PIC18(L)F24/25K40 Family Silicon Errata and Data Sheet Clarification

The PIC18(L)F24/25K40 devices that you have received conform functionally to the current device data sheet (DS40001843D), except for the anomalies described in this document.

Figure 1. 28-pin SPDIP, SSOP, SOIC

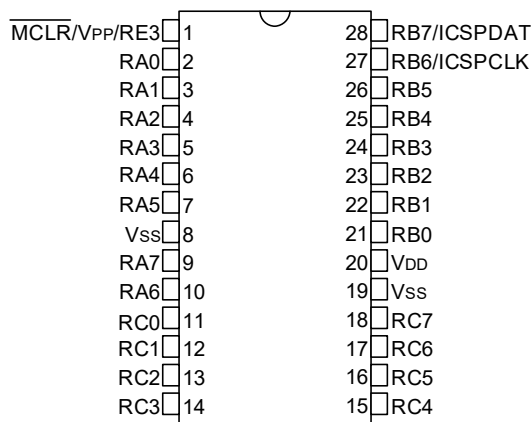
The correct marking for pin 26 on the 28-pin SPDIP/SSOP/SOIC package is **RB5**.

Figure 38-10: ADC Conversion Timing (ADC Clock F_{OSC}-Based)

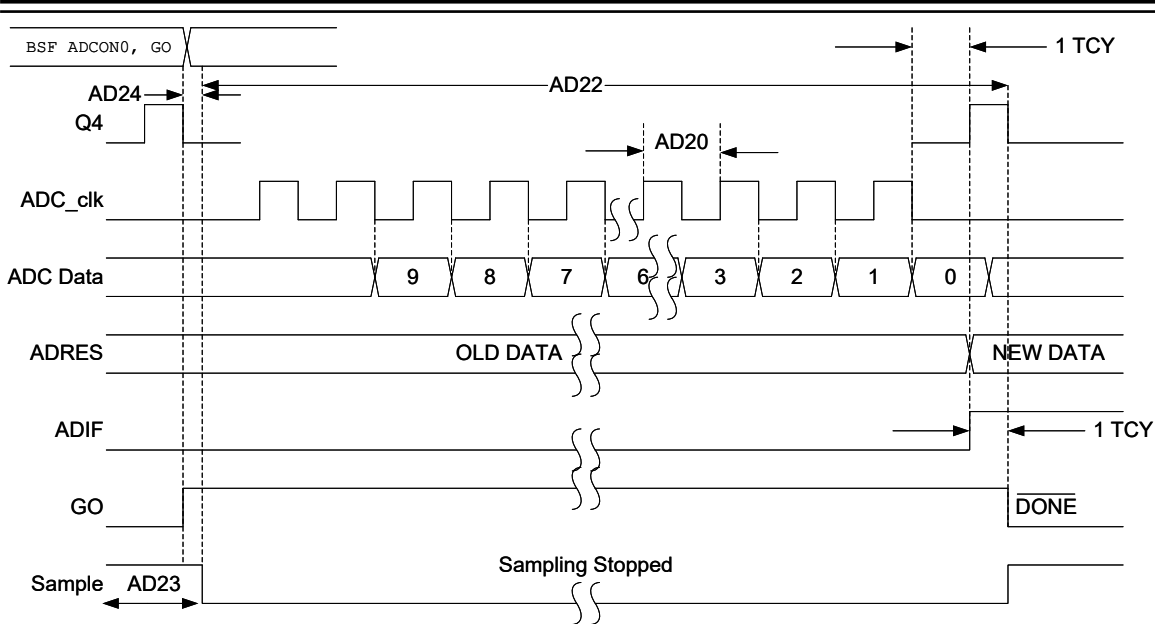
Refer to the images below for corrections of Figure 38-10 and Figure 38-11. Previously, the parameter numbers were incorrect.
